# Final Drainage Report

**St. John the  
Baptist Orthodox  
Church**

**Project No. 61200**

PCD File No. PPR-22-55

DRAINAGE MAP  
(EXISTING)

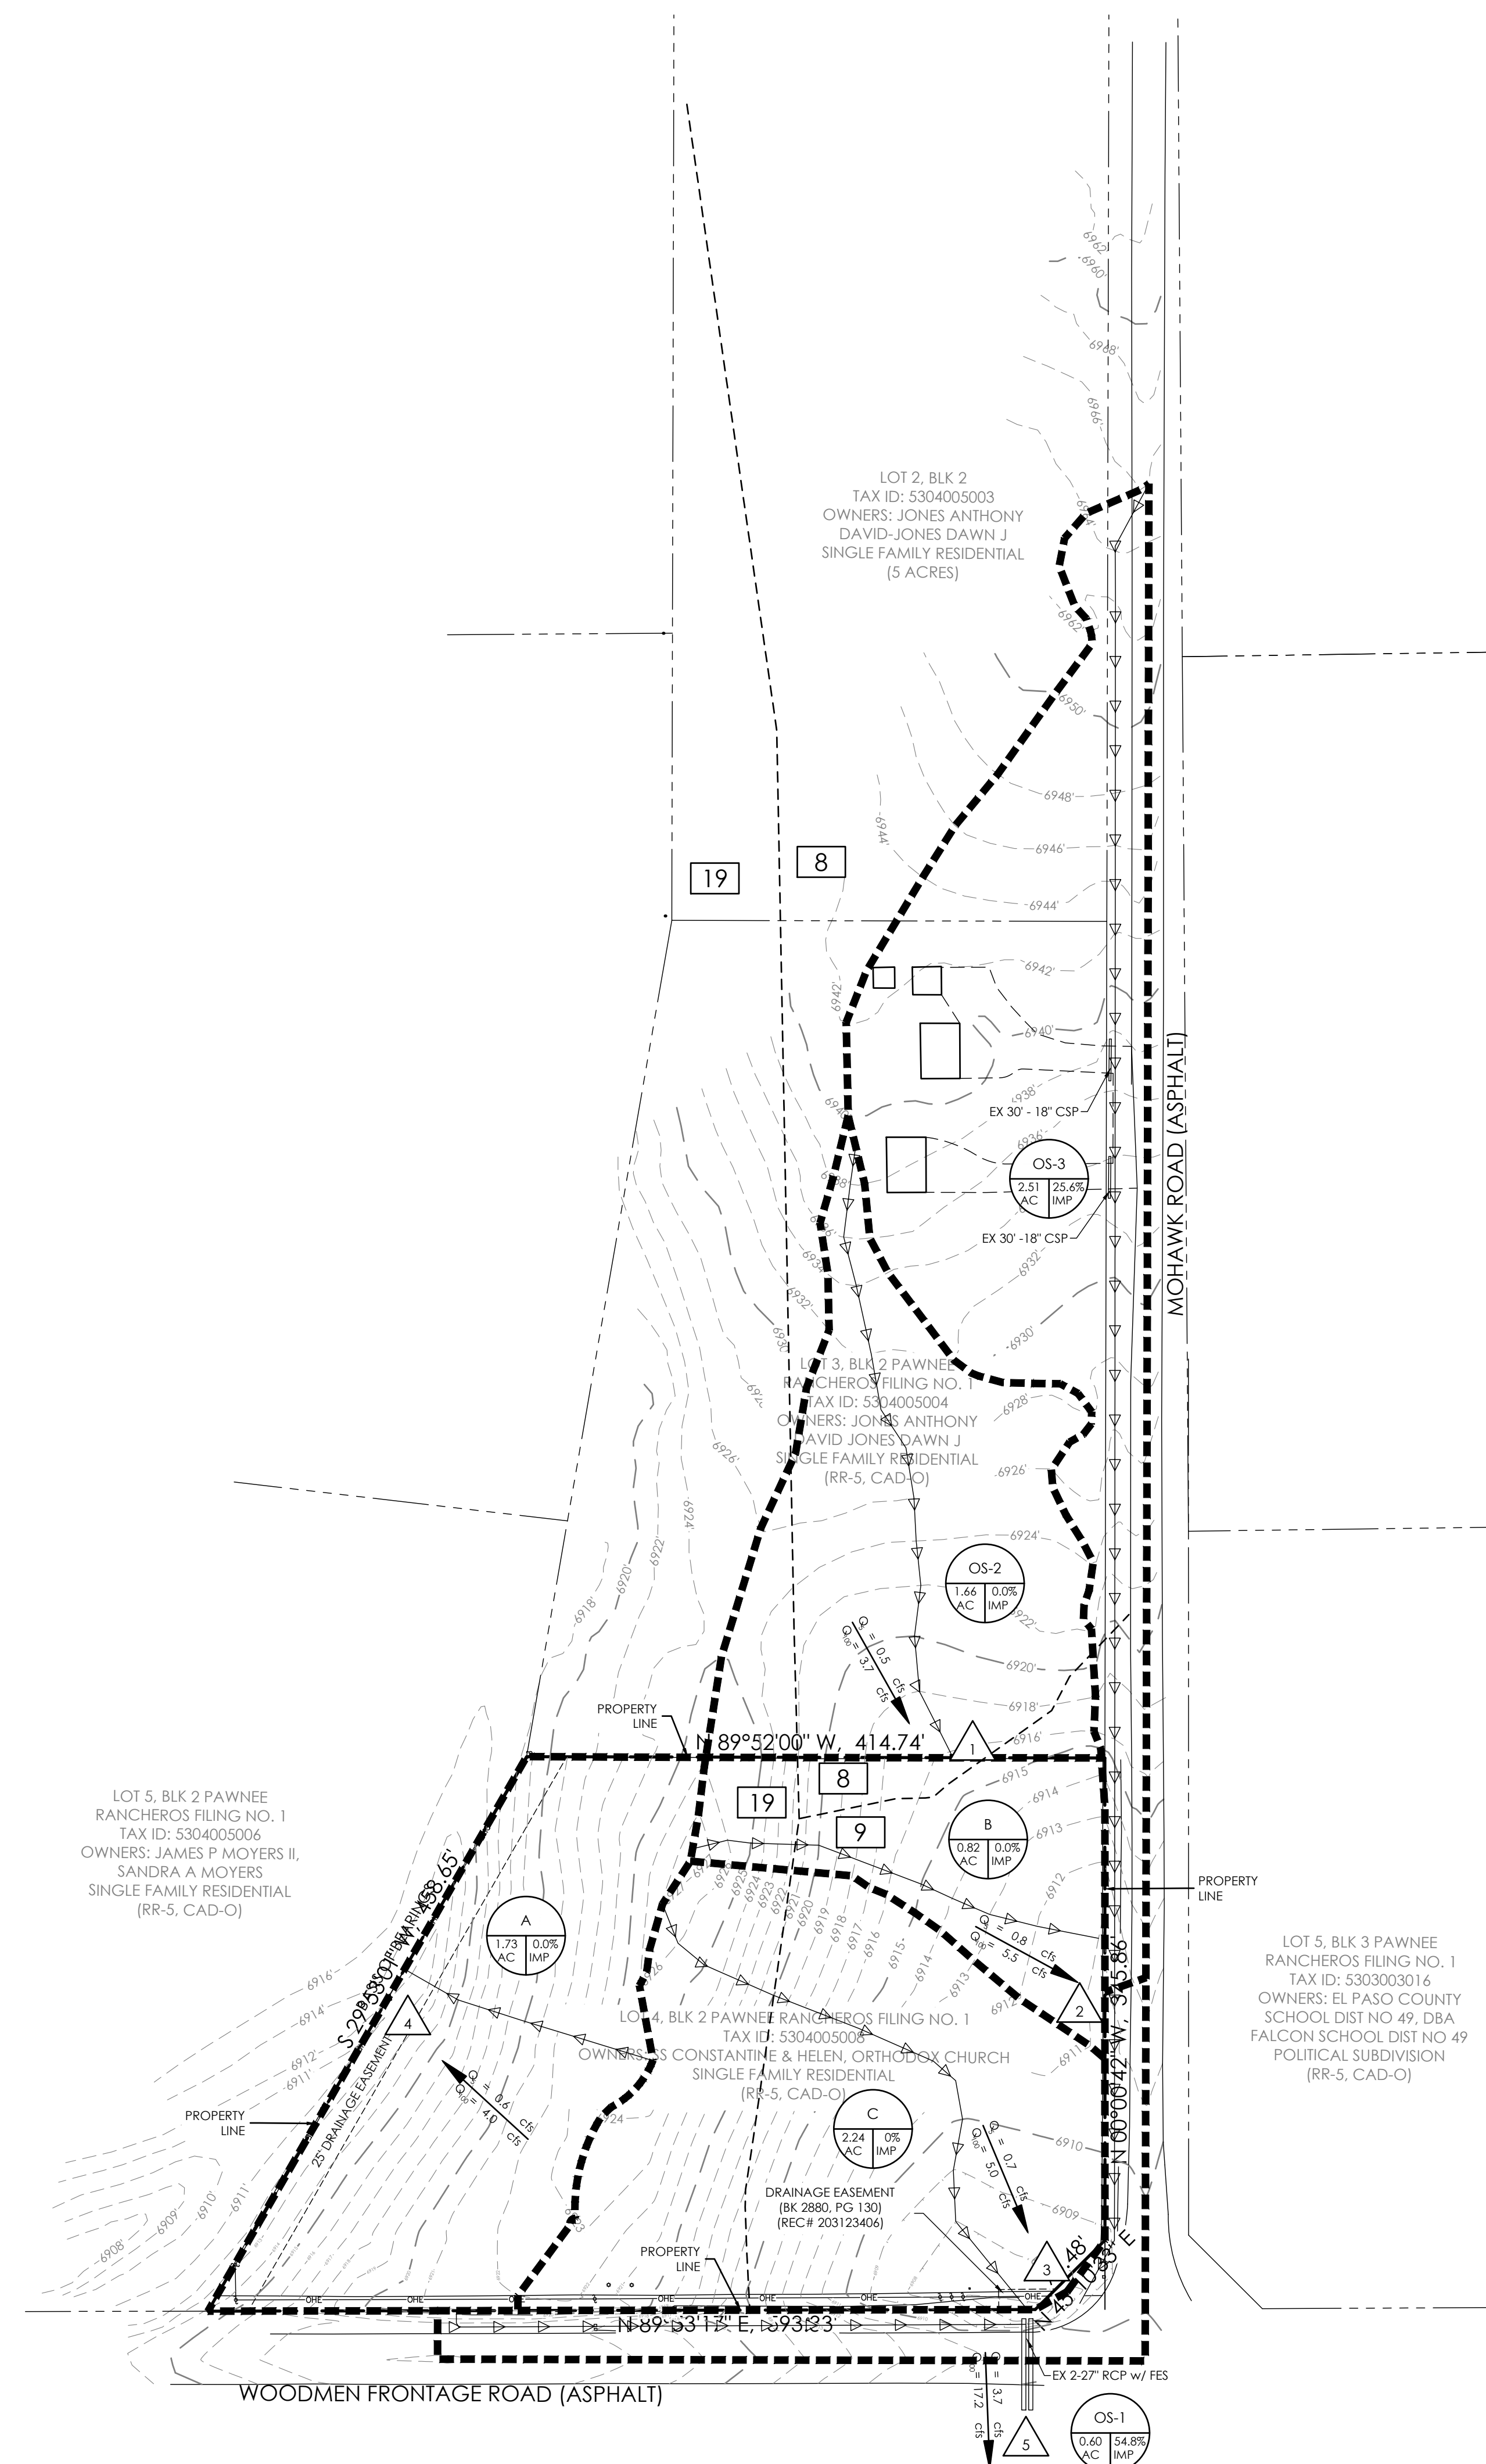
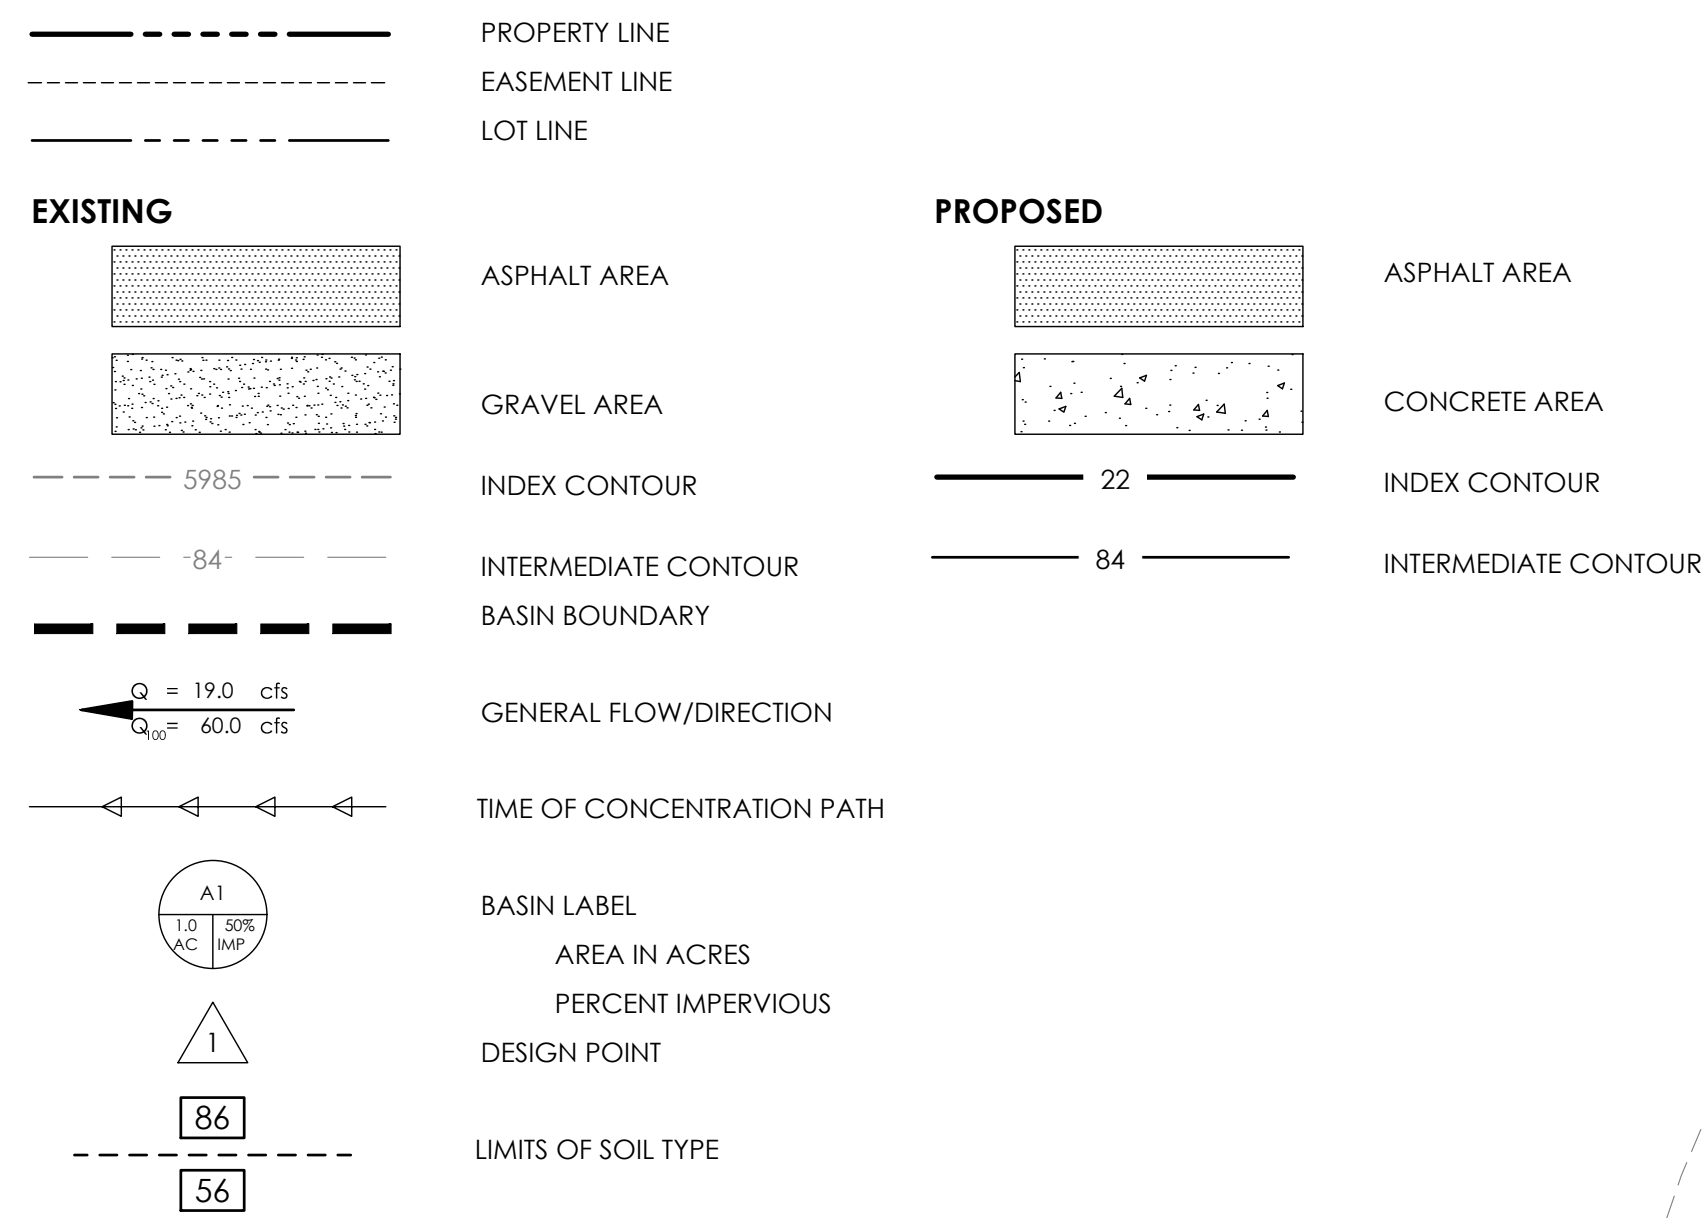
Unresolved:  
Show/label ditches discussed in the report.

MVE PROJECT 61200  
 MVE DRAWING DRAIN-PP

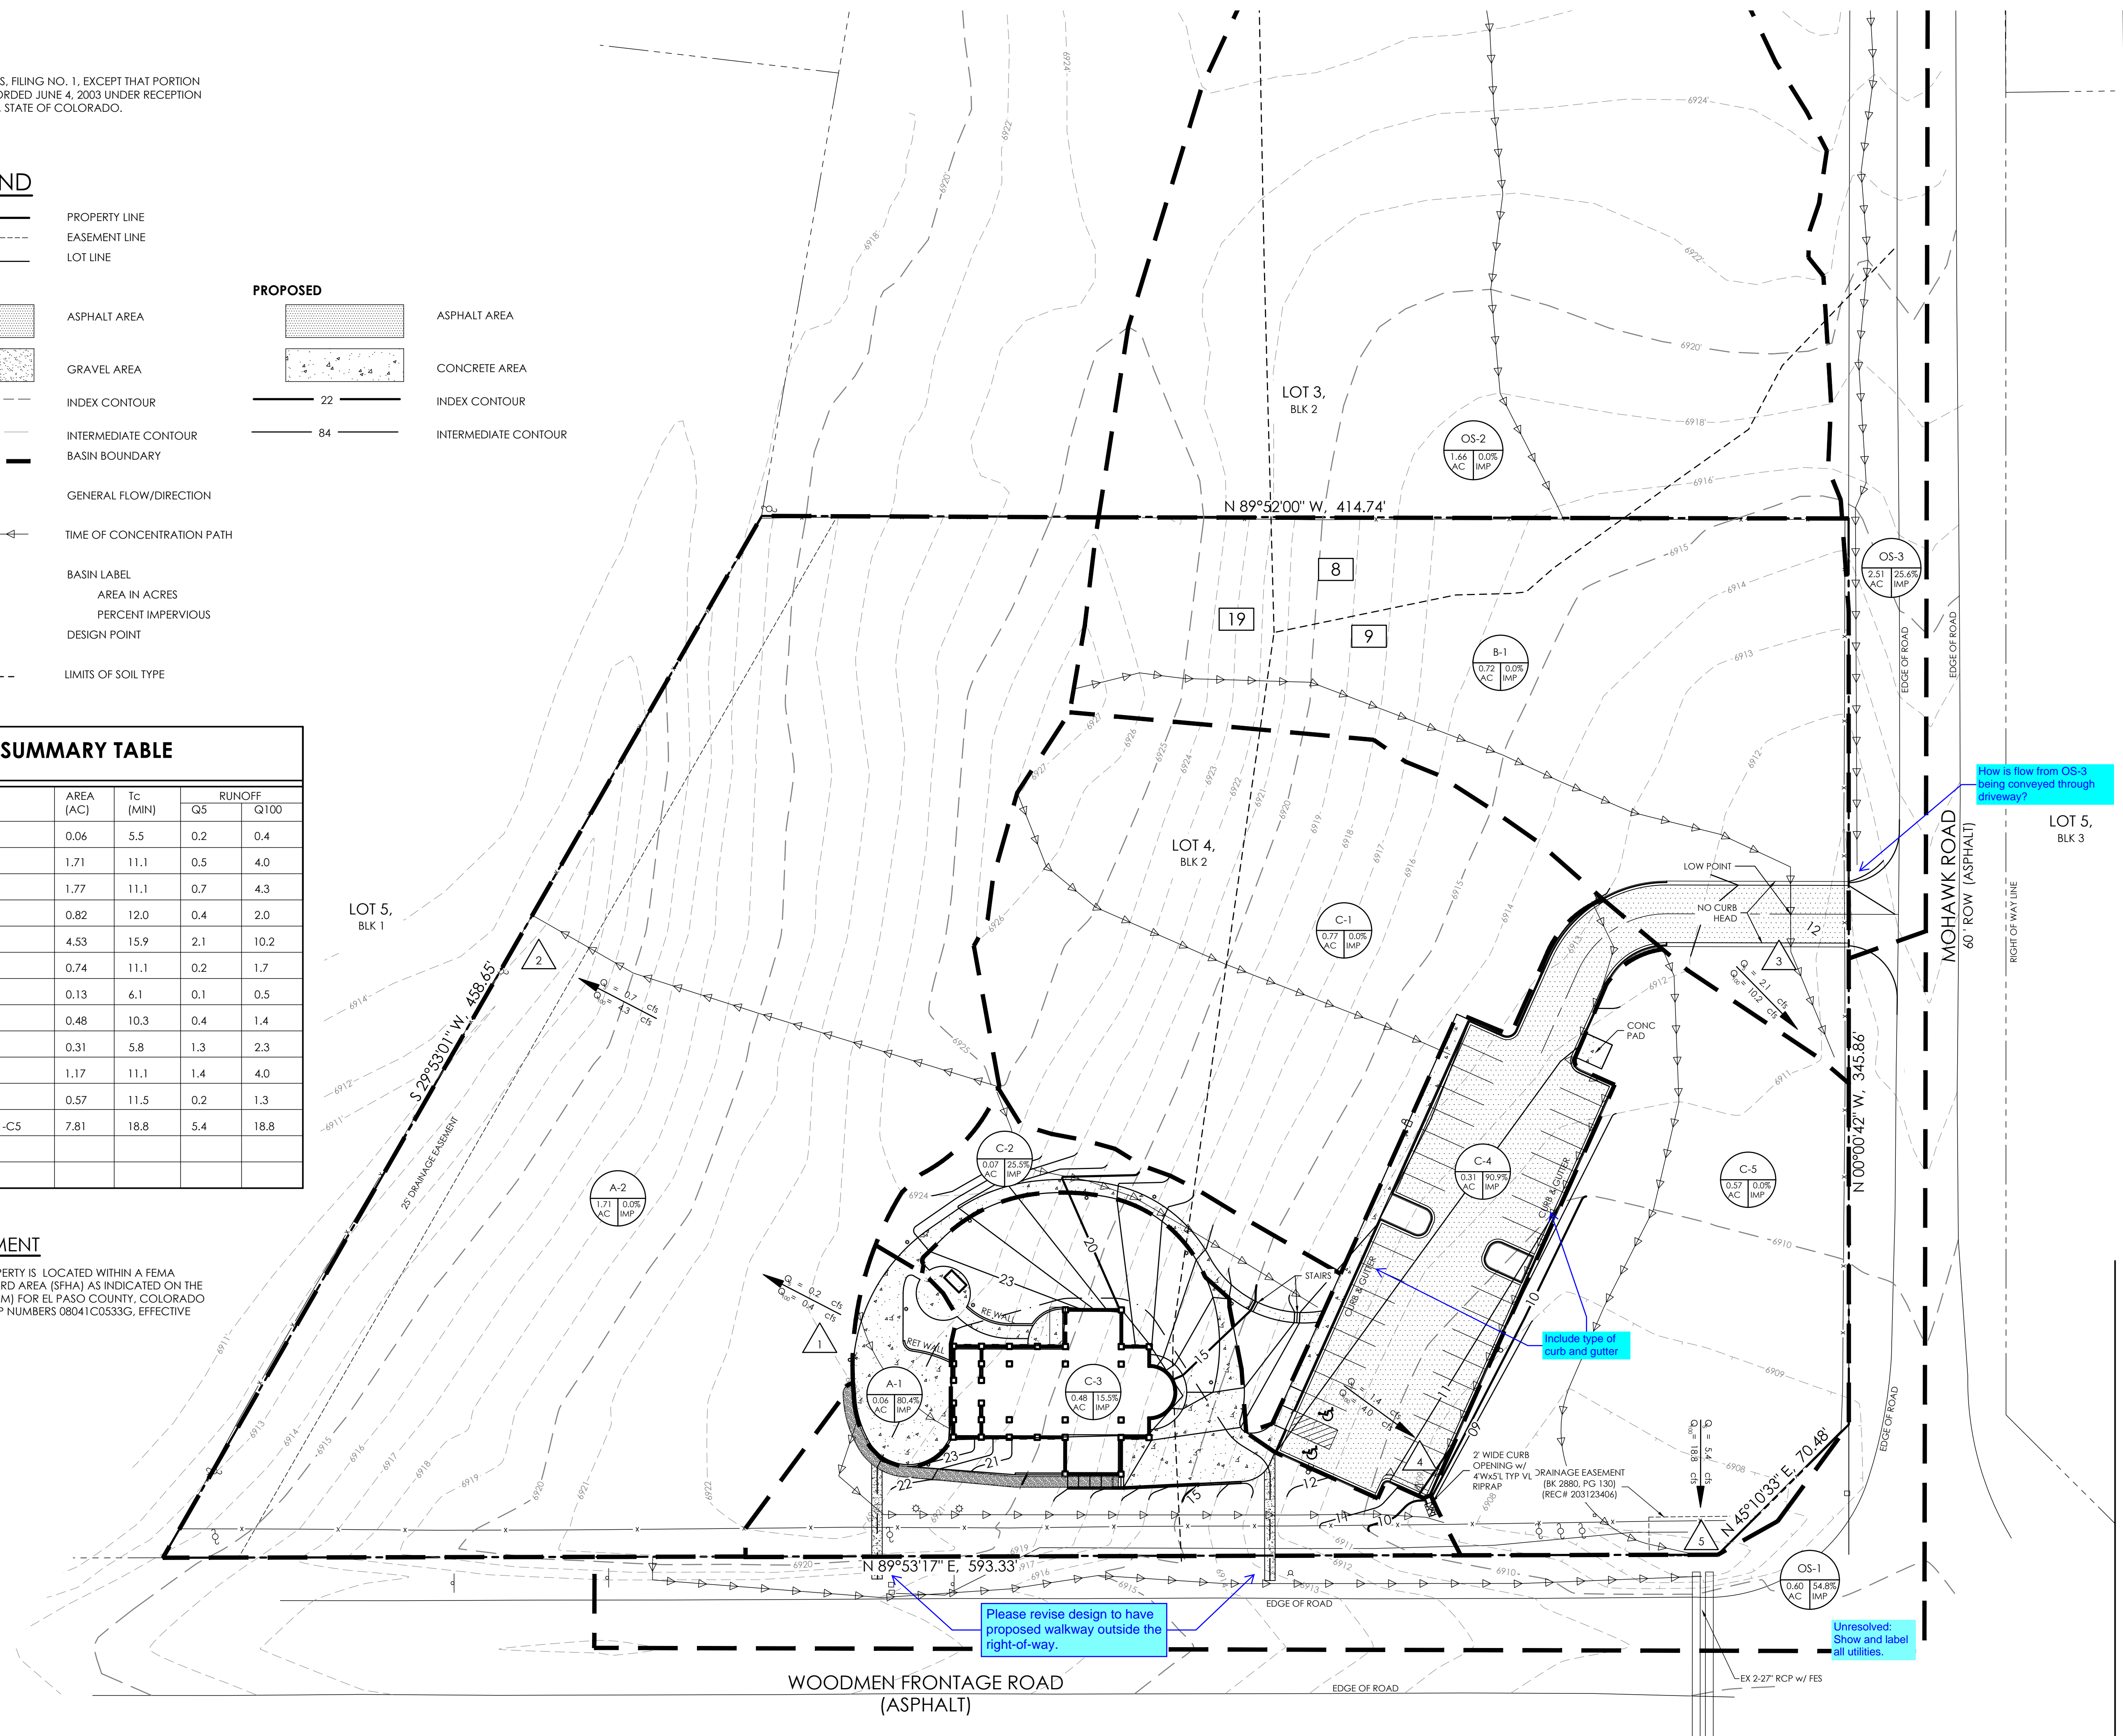
Please revise design to have proposed walkway outside the right-of-way.

Unresolved: Show and label all utilities.
